Office Action Summary	Application No. 10/571,065	Applicant(s) ONDA ET AL.	
	Examiner ERIKA VILLALUNA	Art Unit 2852

DETAILED ACTION

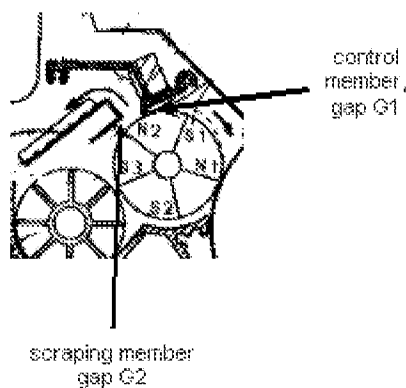
Regarding claims 11 and 15, Endo supply discloses a developer supplying portion (toner replenishment; para. [0017], ll. 5-10) arranged to supply the developer, wherein said stirring roller is disposed between said developer supplying portion and said developing roller (roller 21 is disposed between supplying portion and roller 23), and wherein said one end portion of said reflux plate (26) is disposed in a vicinity of an

outer periphery on said developer supplying portion side of said stirring member (bottom left portion of plate 26 is disposed in the vicinity of the developer supplying portion).

Regarding claims 17-20, Endo discloses a scraping member (bottom right corner portion of plate 26) physically attached to said reflux plate (26) at a vicinity of said reflux plate disposed of an outer periphery of said developing roller (26 is disposed at an outer periphery of developing roller 23), wherein said scraping member faces said developing member (bottom right corner portion of plate 26 faces developing roller 23) wherein said scraping member is integrally formed with said reflux plate (bottom right corner portion of plate 26 is integrally formed with plate 26); wherein a gap (G2) exists between said scraping member and said developing roller (a gap exists between bottom right corner portion of plate 26 and developing roller 23); wherein the gap G2 is a second gap, wherein a first gap (G1) exists between said control member (24) and said developing roller, and wherein a relationship $G1 < G2$ holds true (gap between bottom right corner portion of plate 26 and developing roller 23 is larger than a gap between regulating board 24 and developing roller 23). See annotated figure below.
